# Section 4.55(1A) Modification Application

SSD 49295711 MOD 8

Harbourside Shopping Centre Redevelopment – Podium & Tower

Prepared by Ethos Urban, a Colliers Company.  
25 September 2025 | 2210627

**Figure 4** SSD 49295711 built form, MOD 7 (top) and as amended without North Bridge (bottom)

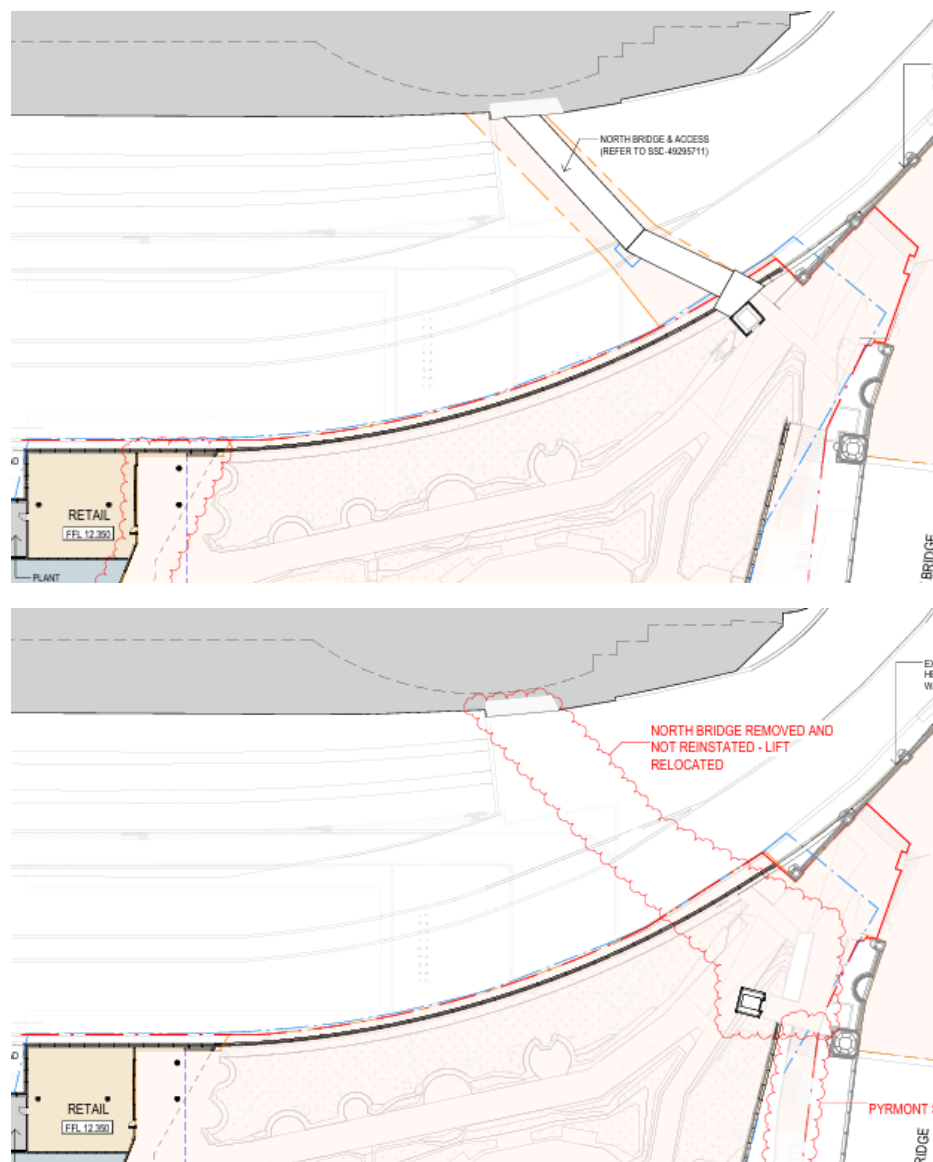
It is proposed to amend the SSD 49295711 built form to accommodate the removal of the North Bridge connection at the Waterfront Promenade under SSD 7874 MOD 6 (**Figure 4**). Amendments to the built form are minor in nature and comprise the removal of the stair access to the North Bridge, and relocation of the pedestrian lift (which is further described below).

**Figure 5 MOD 7 (left) vs amended (right) lift location – ground level (Waterfront Promenade)**

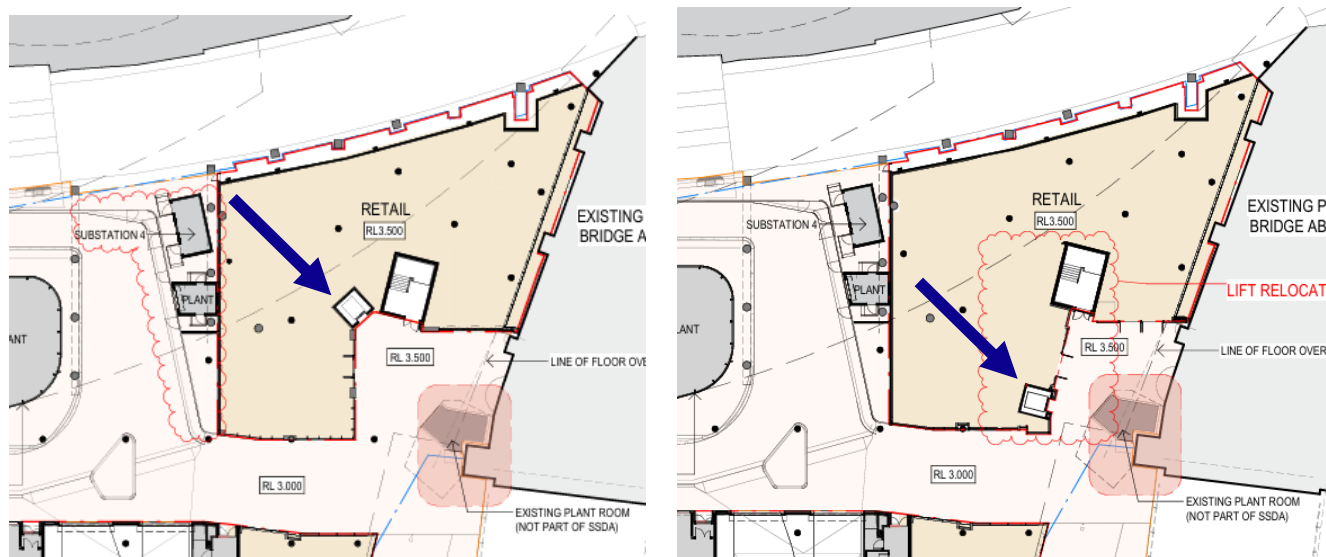
A comparison between the approved and proposed location of the pedestrian lift is provided in **Figures 5 – 6** below. Additional information and design justification is provided in the Amended Architectural Plans (**Appendix A**) and accompanying Design Report (**Appendix C**) prepared by Snøhetta + Hassell.

**Figure 7 Public benefit works-in-kind area assessment**

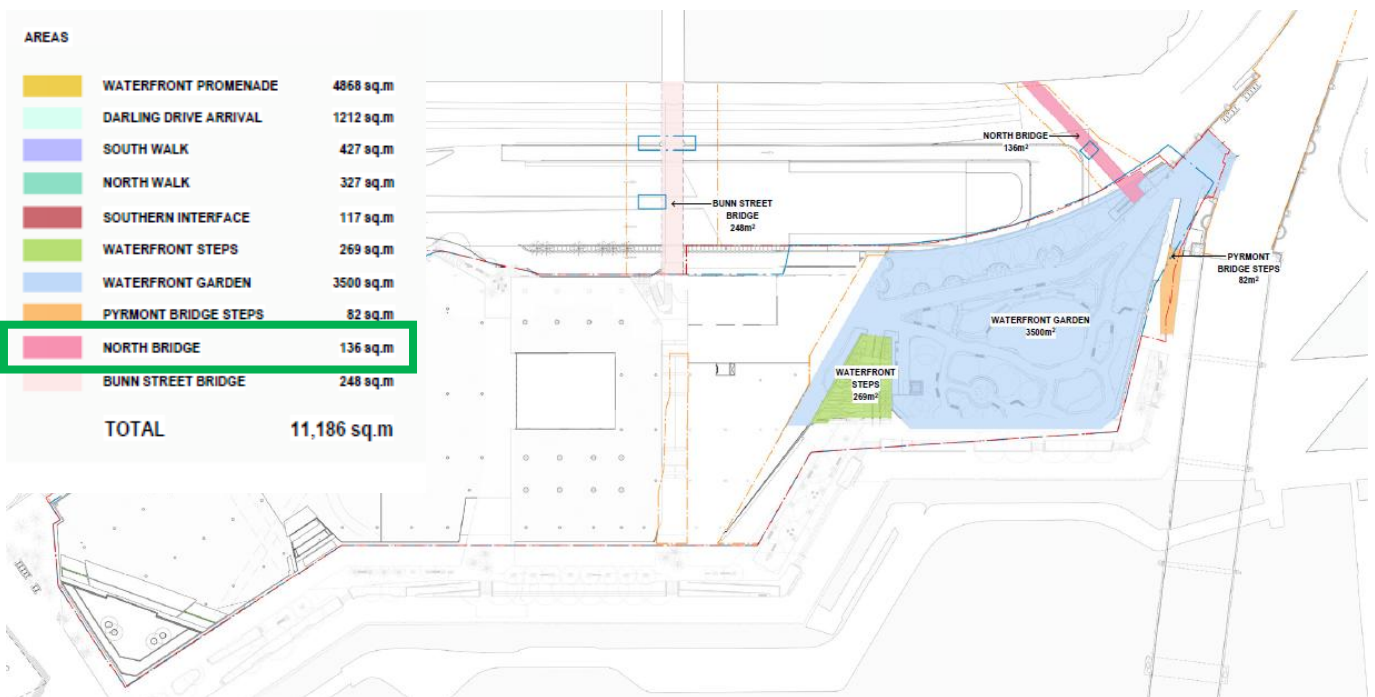
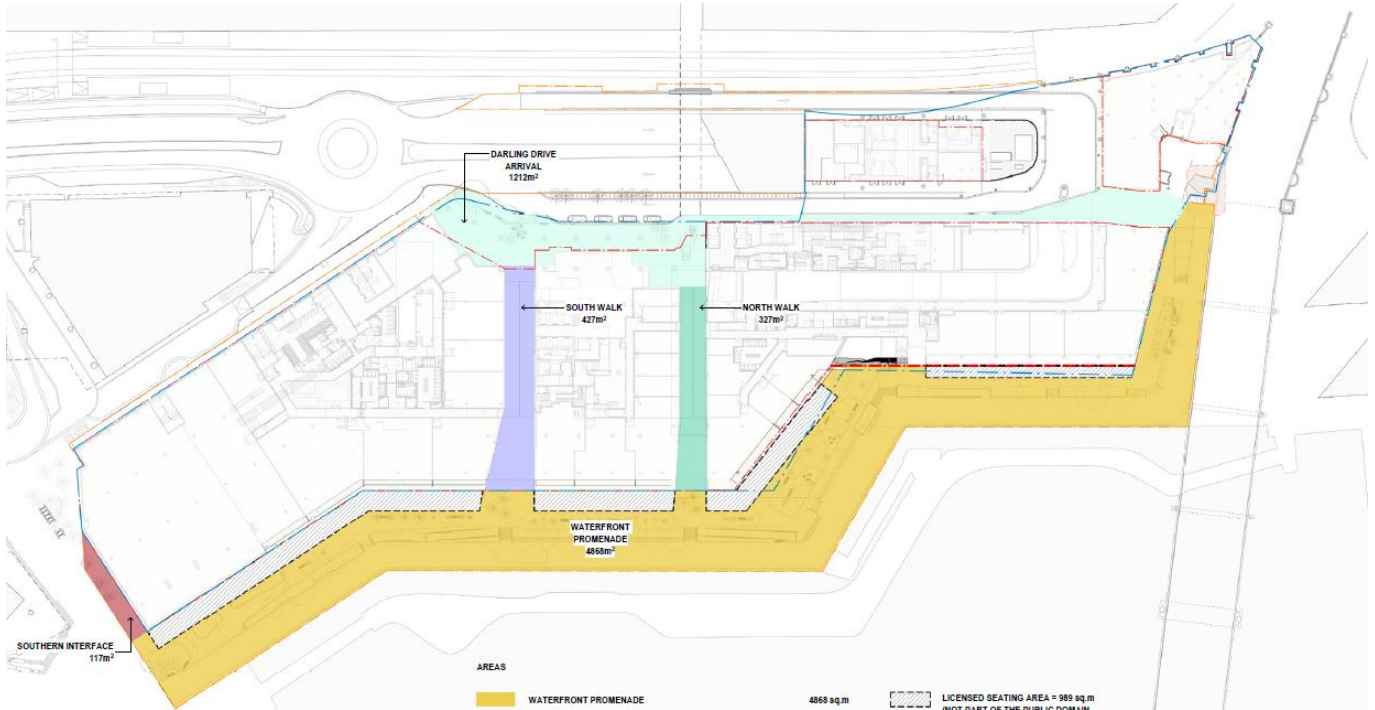
It is noted that the Design Guidelines require a minimum 10,200sqm area of public domain works in kind to be provided. As part of SSDA3, confirmation that 11,186sqm of works in kind area would be provided was provided to DPHI – refer to **Figure 7**. Of this, 136sqm was attributed to the North Bridge. Therefore, in light of removal of the

bridge, the 10,200sqm will still be exceeded – and this does not include the additional public benefit area of the relocated rectifier room and upgrades to public amenities within the Pyrmont Bridge.

**Figure 8** Compliance with Waterfront Garden area requirement

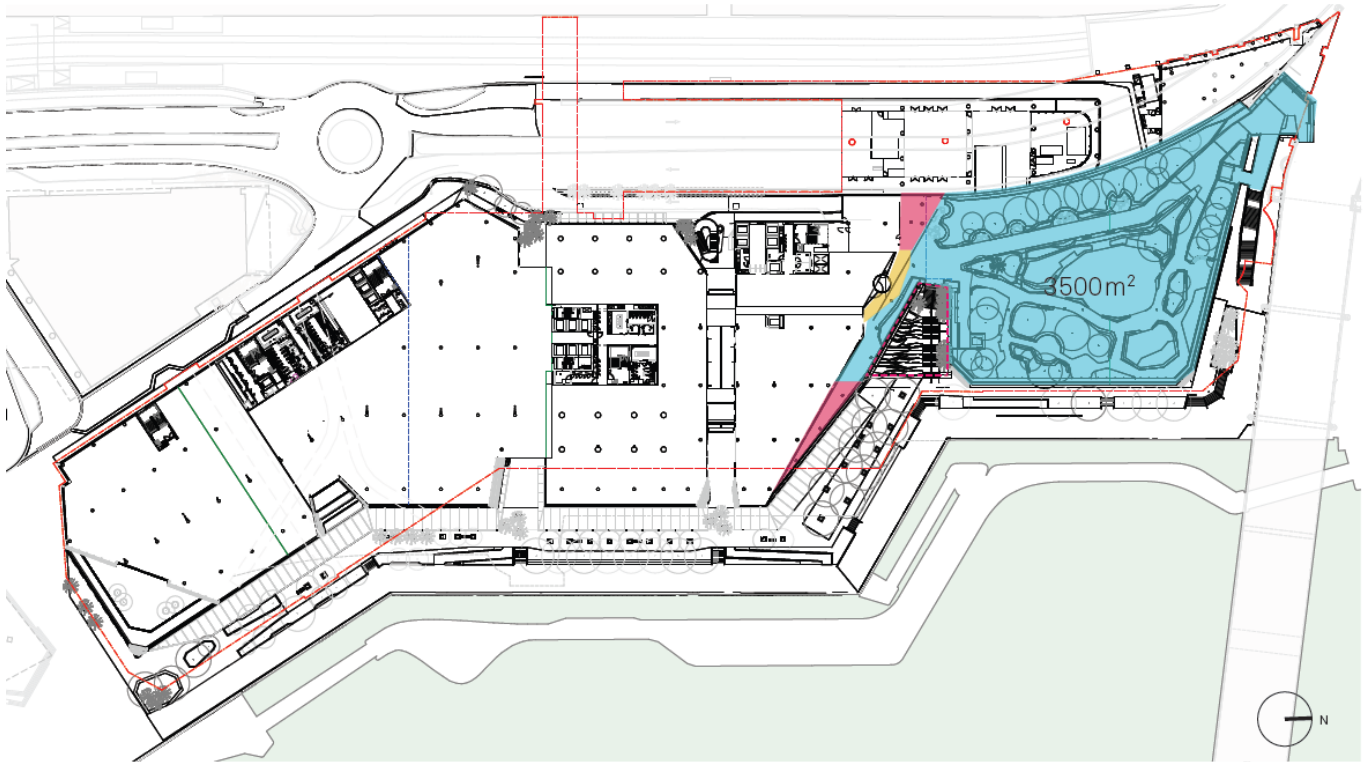
Further, the requirement in the Concept Plan approval to provide a minimum of 3,500sqm area in the Waterfront Garden is also retained, as demonstrated at **Figure 8**.

**Figure 9** Existing (left) vs amended (right) lift location, showing significantly improved connectivity and visibility

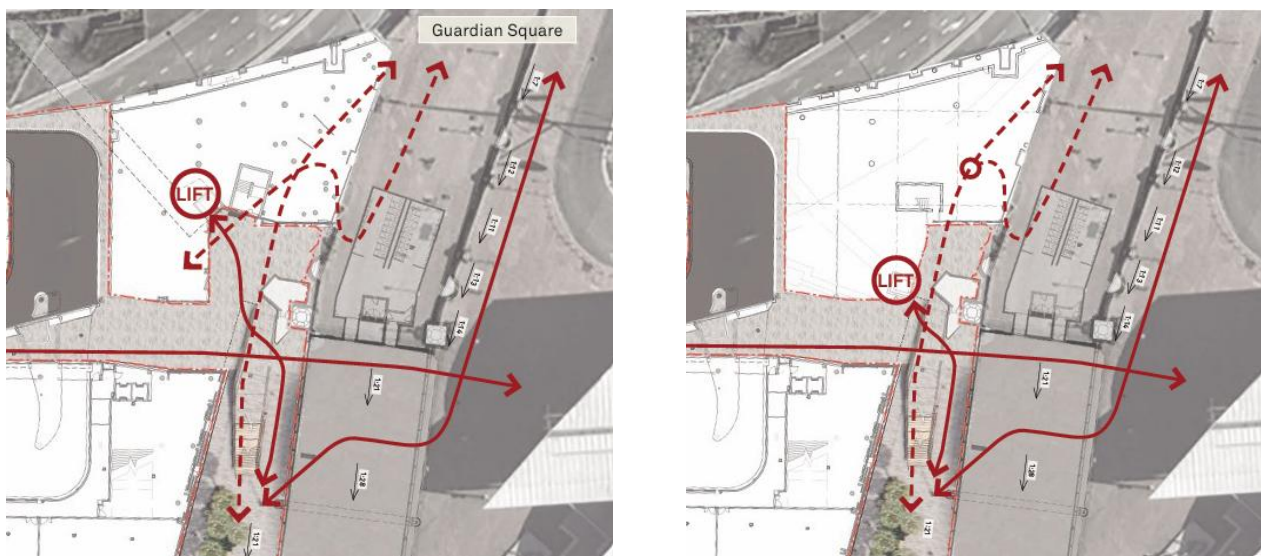
In contrast, the relocated lift offers closer proximity of the lift with the Pymont Bridge Steps, greater visibility of the lift from the Waterfront Promenade approach, and greater visibility from the western edge of the building. This enables the creation of a new ‘nodal point’ towards the north of the site, creating a vertical connection to the Waterfront Gardens as well as Pymont Bridge and Pymont itself (**Figure 7** below).
